UCRL-AR-113861 Add

**Addendum to the Pit 6 Engineering
Evaluation/Cost Analysis
Lawrence Livermore National
Laboratory Site 300**

November 1996

Figure 4. Proposed location of pit 6 cover and surface water diversion ditches.

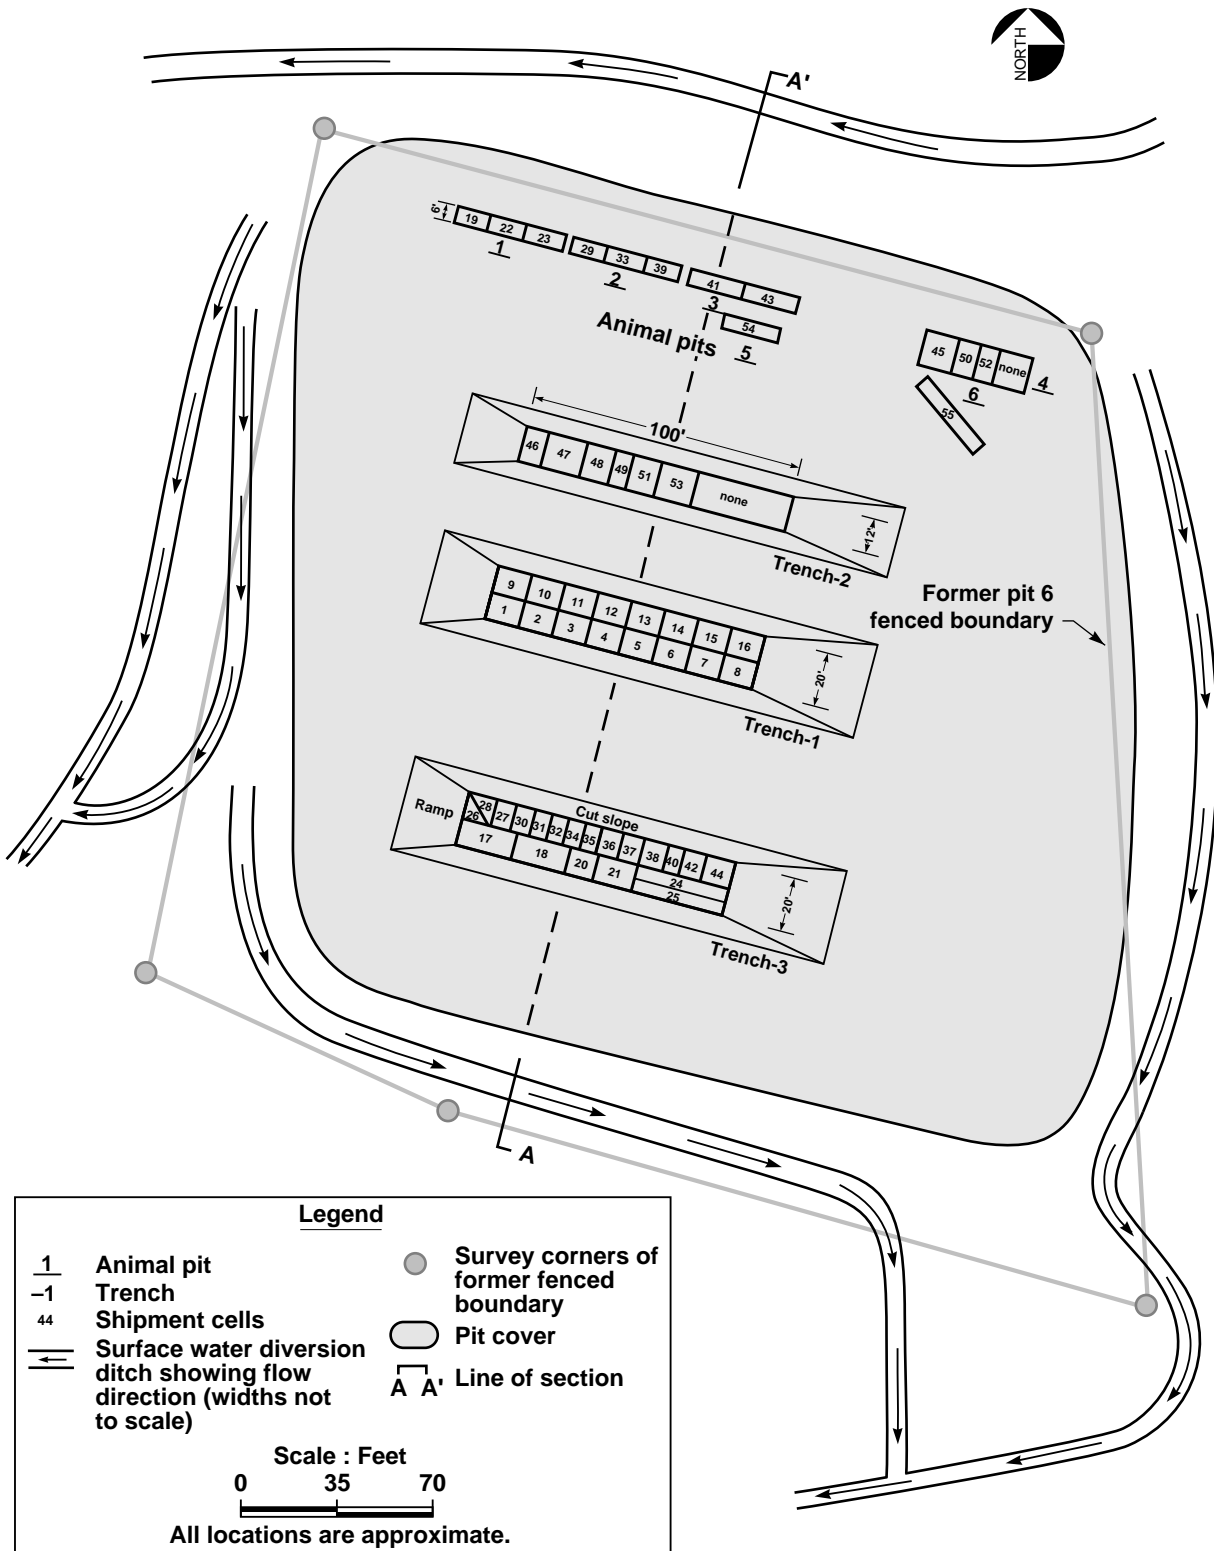
Alternative 2 of the EE/CA showed the landfill cover covering an area of about 63,000 ft² (1.5 acres). Further review of geophysical data and historical survey data suggests that some of the buried wastes may be located further east than was presented in the SWRI. The uncertainty of the buried waste contents, potential for void space collapse under heavy equipment, and access restrictions preclude better definition of the areal extent of the buried waste. Therefore, the areal extent of the proposed landfill cover has been expanded to approximately 2.4 acres. Figure 4 shows the proposed expanded area for the landfill cover, as well as revised locations of the buried waste. Surface water drainage outfall has also been changed to drain to the south and the southwest of the landfill cover instead of only to the southwest.

Figure 6. Typical section for the proposed pit 6 cover.

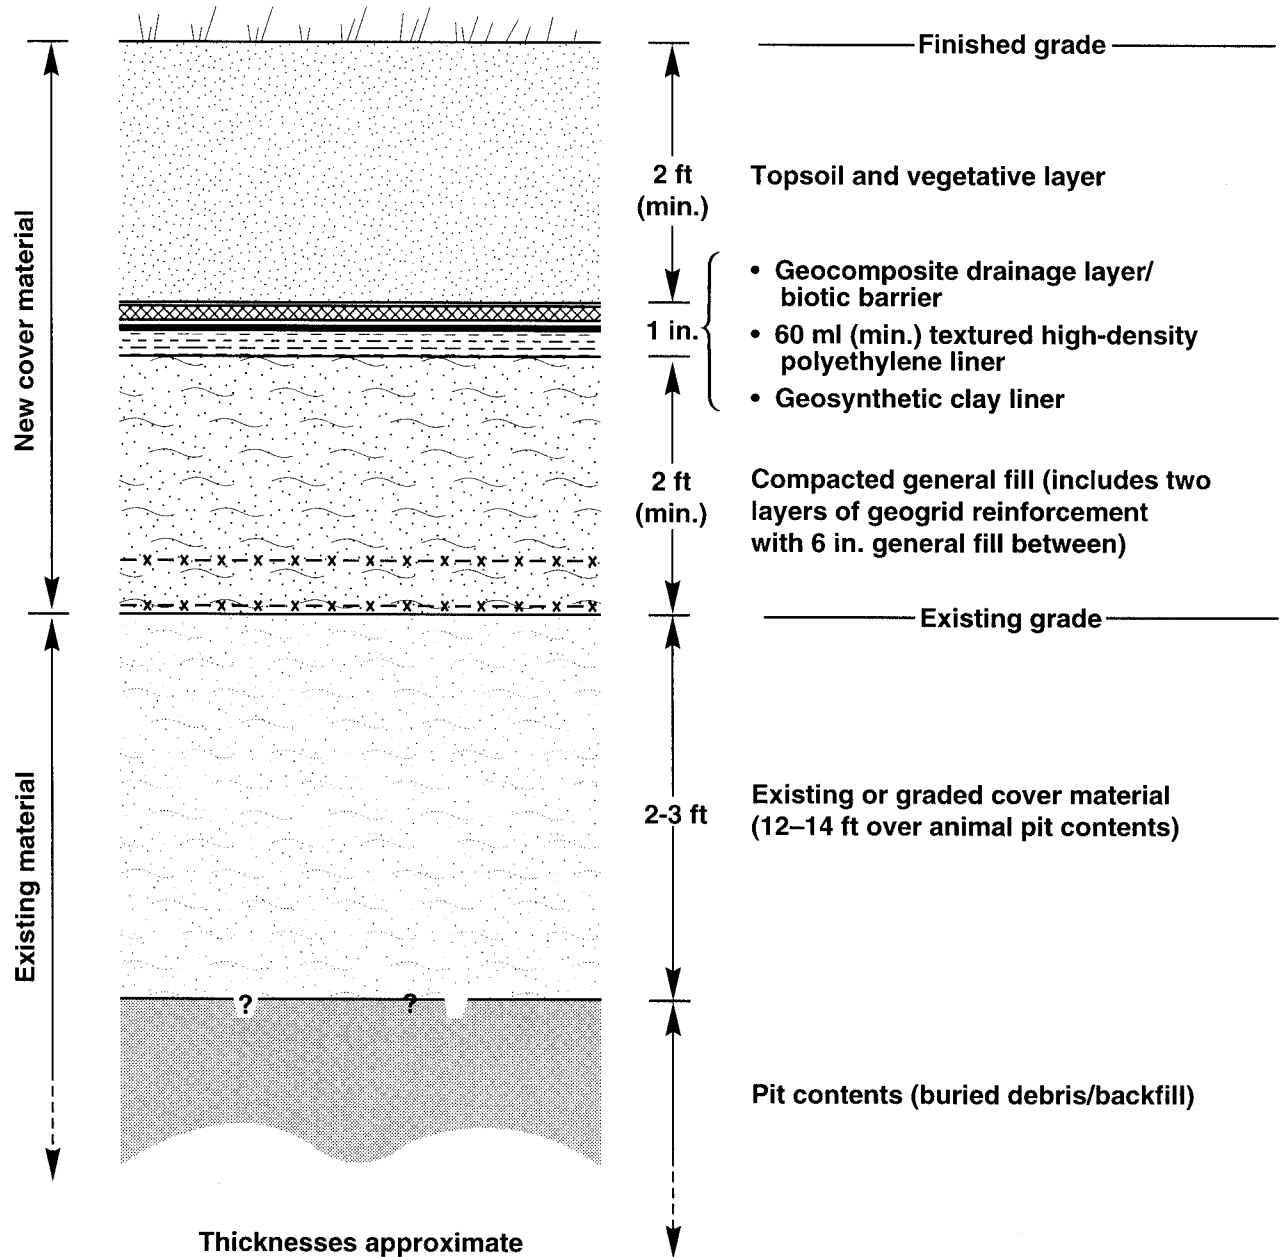
The revised design of the engineered layers for the landfill cover consists of:

- Installation of geogrid structural reinforcement in the lower portion of the foundation layer to prevent collapse into void spaces.
- Use of a geosynthetic clay liner system instead of a 2-ft clay layer for the low-hydraulic conductivity layer. This layer will meet or exceed the 1×10^{-7} cm/sec hydraulic conductivity requirement, and is less likely to develop desiccation cracks during or after construction, which is a potential problem with conventional clay layers. Additionally, installation is faster, material costs are less, and overall landfill cover weight is reduced.

- Replacing the cobble biotic layer and associated sand base with a geocomposite drainage layer, thus reducing the overall landfill cover weight and reducing the risk of significant subsidence into buried waste void spaces. This layer, in conjunction with the underlying 60-mm, high-density polyethylene liner, will deter animals from burrowing through the landfill cover.

Figure 7. Ground water monitoring network — revised Alternative 3.

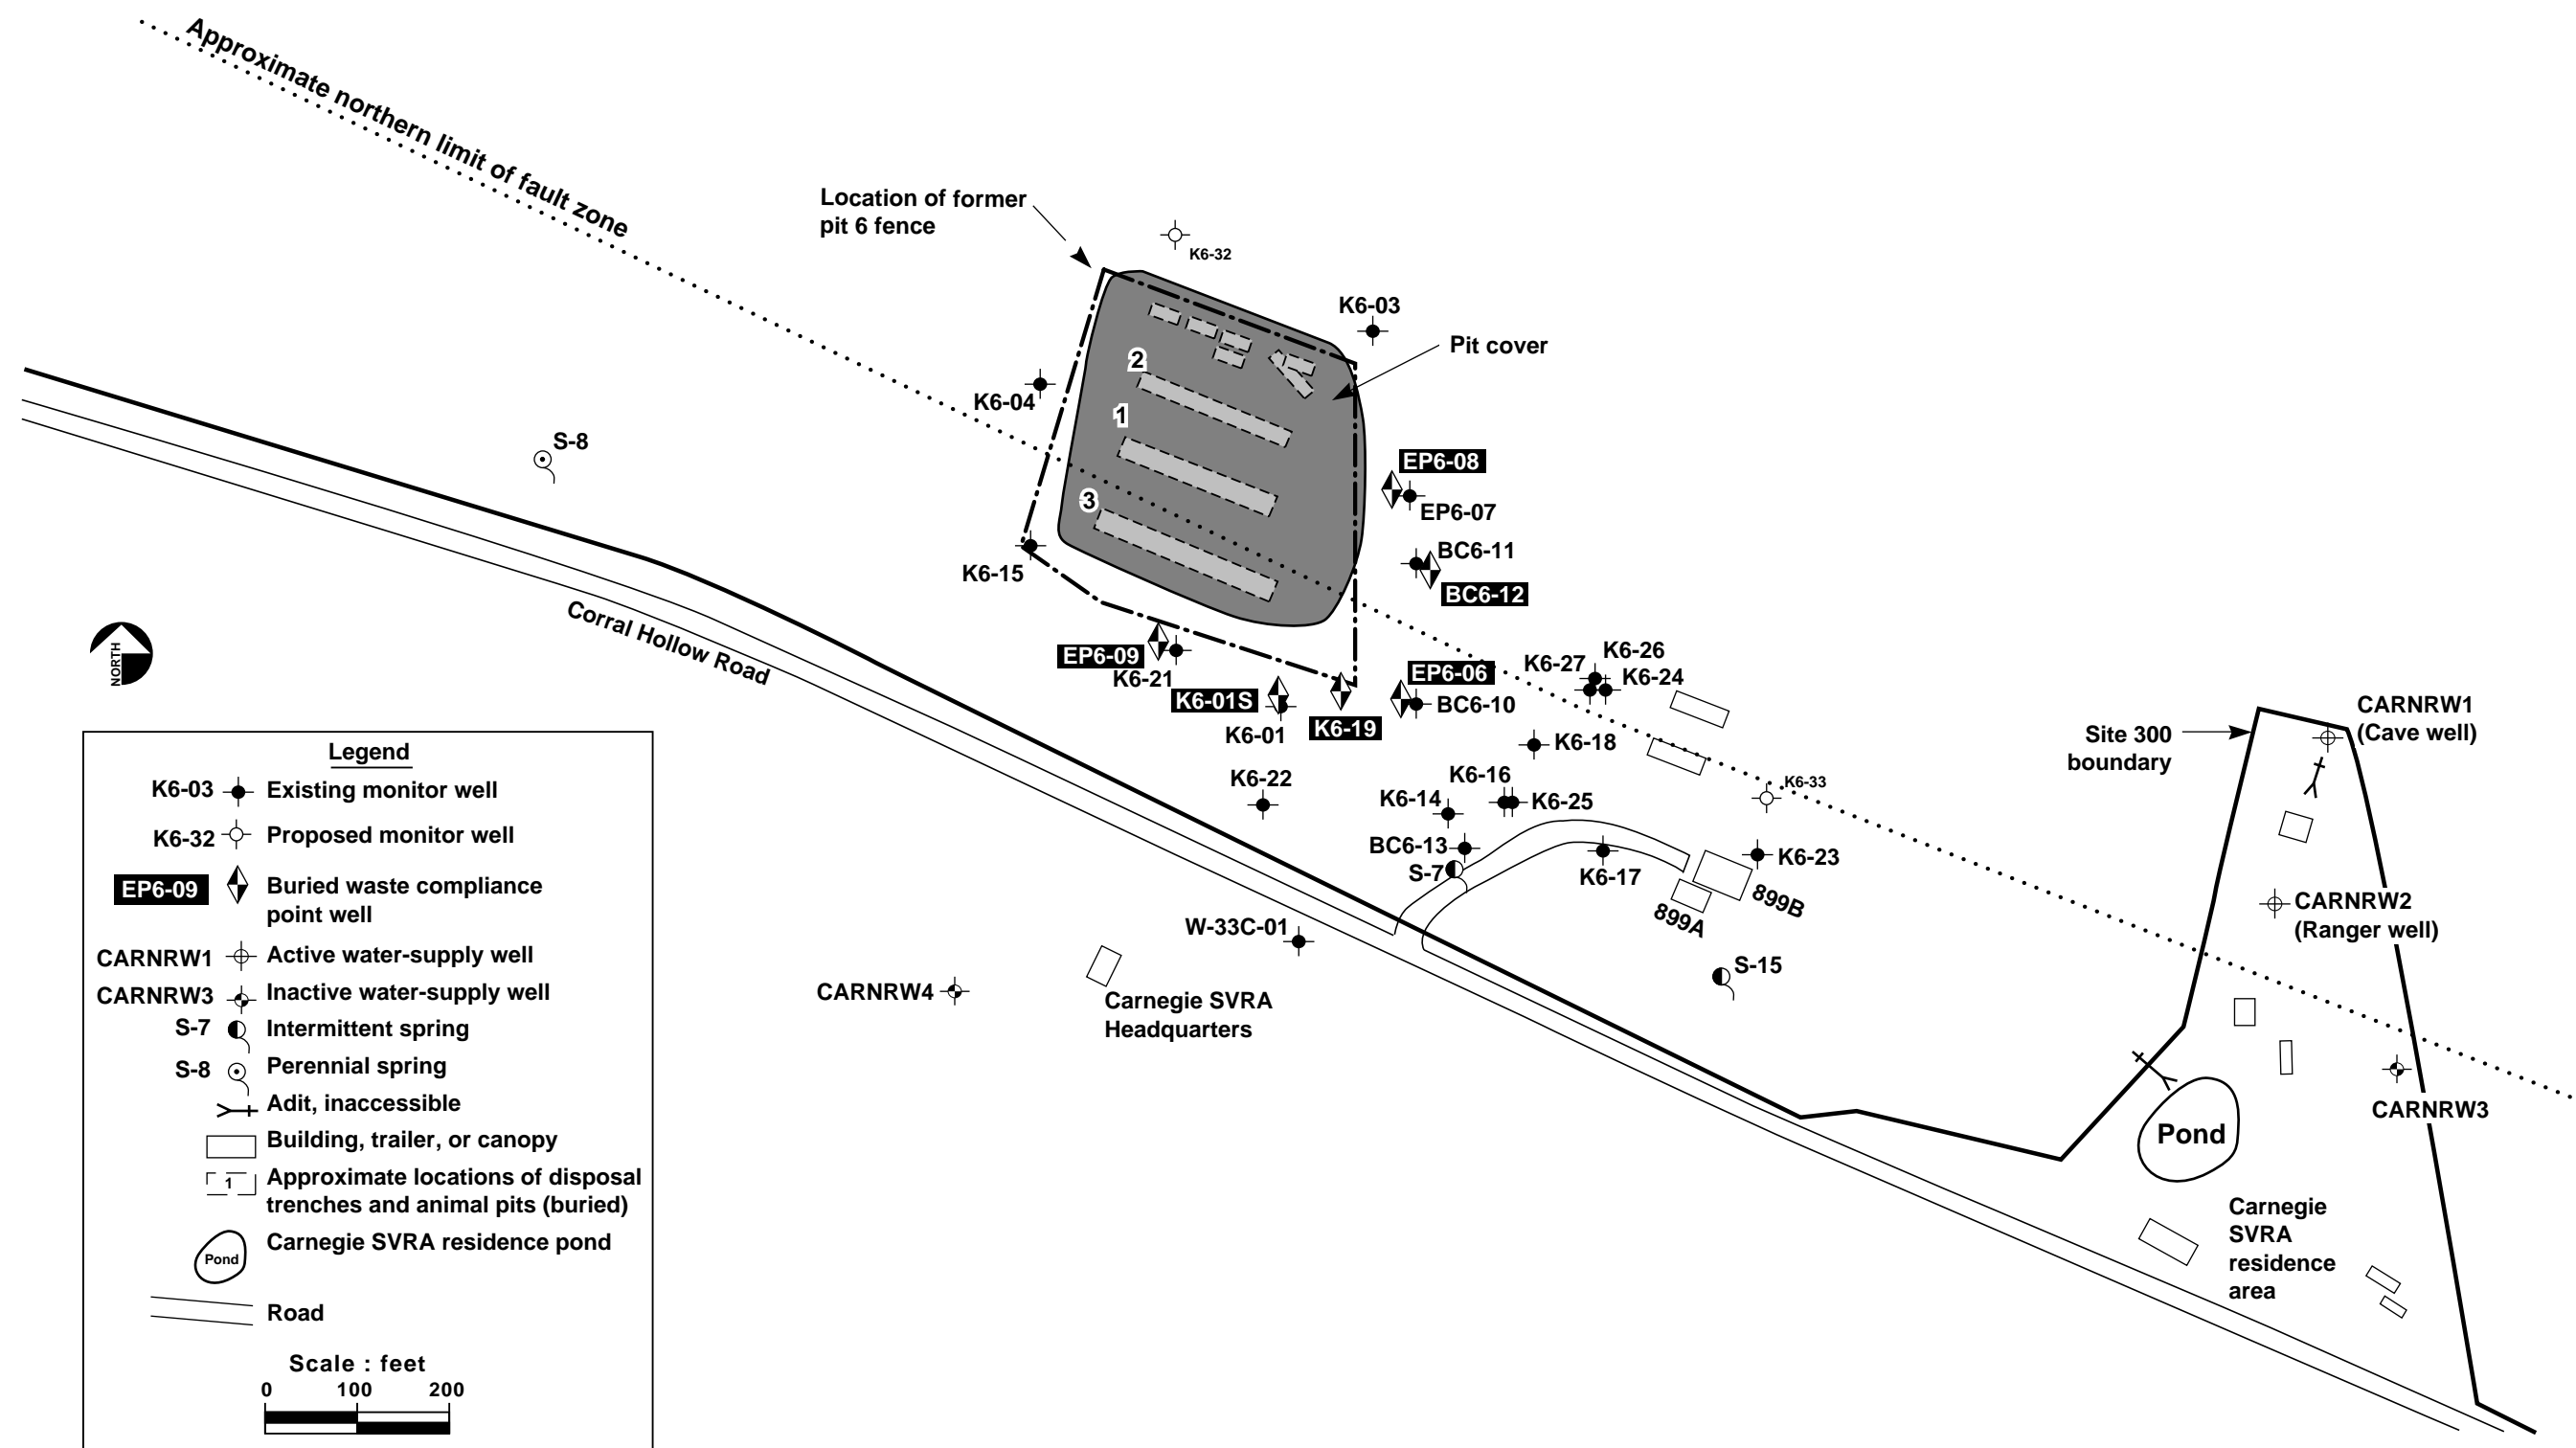
Figure 7 shows the ground water monitoring network for revised Alternative 3. The ground water monitoring plan reflects two objectives:

Six proposed ground water monitor wells located in the buried waste area described in the EE/CA (wells P6-01 through P6-06) have been reduced to one proposed new well, K6-32 (formerly P6-06). Well K6-32 will be installed immediately upgradient of the landfill cover near the northwest corner (Fig. 3) to provide a location for monitoring water elevations and background concentrations. Wells P6-01 through P6-05 will not be installed because:

Proposed monitor well K6-33 has been moved about 200 ft east of its initially proposed location. It is downgradient of well K6-18 and will monitor the shallow ground water plume along the gravel channel (Qt) depicted in Figure 1-19 of the EE/CA. Because the Qt is shallow and only a few feet thick at this location, the screen for K6-33 will probably need to extend into the underlying bedrock to reach below the water table. If VOCs are detected in K6-33, another shallow monitor well, and possibly a deeper monitor well, may be installed further downgradient.
